ADDENDUM NO. 1 DATED 4/2/2013 ADDENDUM NO. DATED
 ADDENDUM NO. DATED ADDENDUM NO. DATED

Chip Seal on SR 35, known as State Project No. MP-2035-08(006) & MP-2035-22(002) / 304602301 & 302 in Carroll and Grenada Counties.

SPECIAL PROVISION NO. 907-410-7

SUBJECT: Bituminous Surface Treatments

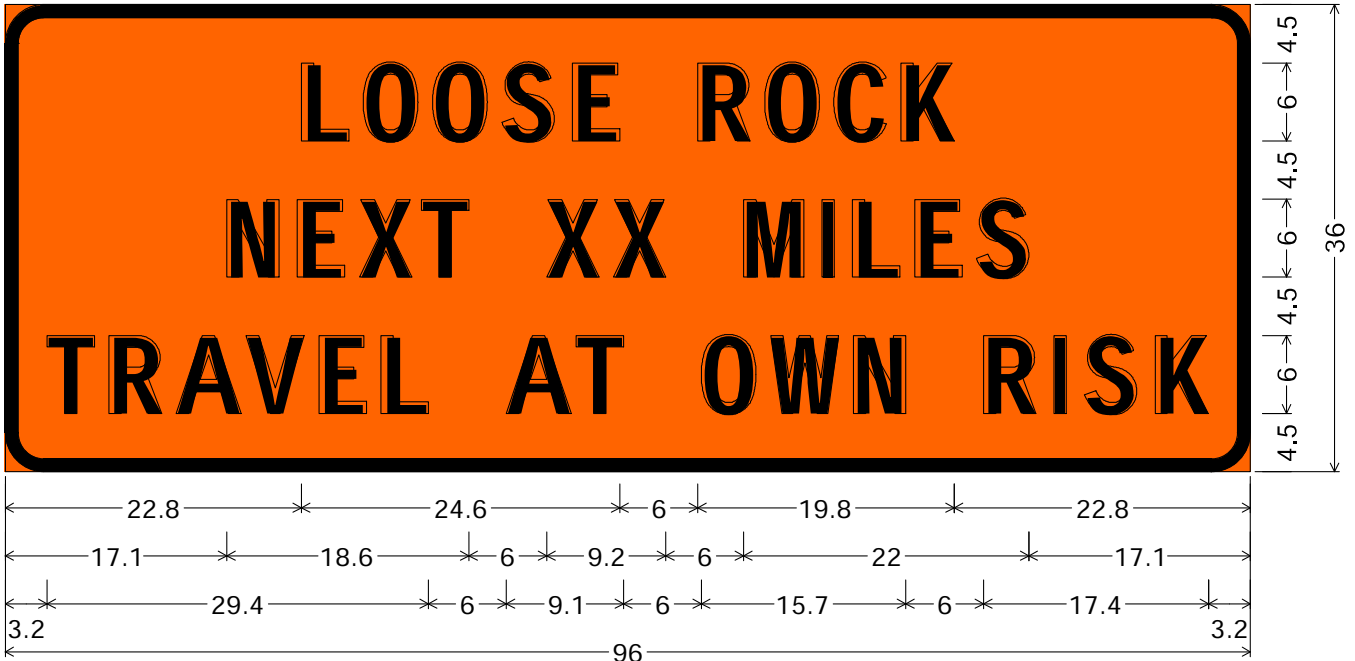
The attached sign drawings shall be used during sealing operations. Prior to any sealing operation, the rectangular “Loose Rock” signs shall be installed and remain in place until all sealing operations are complete. Prior to any daily sealing operation, the portable “Loose Rock” signs shall be installed in accordance with the attached drawings. Portable signs shall be installed and remain in place on a daily basis in the active sealing area. Payment for signs shown on the sign detail drawings shall be made under pay item no. 618-A, Maintenance of Traffic.

3.0" Radius, 1.0" Border, Black on Orange;

"LOOSE ROCK" D; "NEXT XX MILES" D; "TRAVEL AT OWN RISK" D;
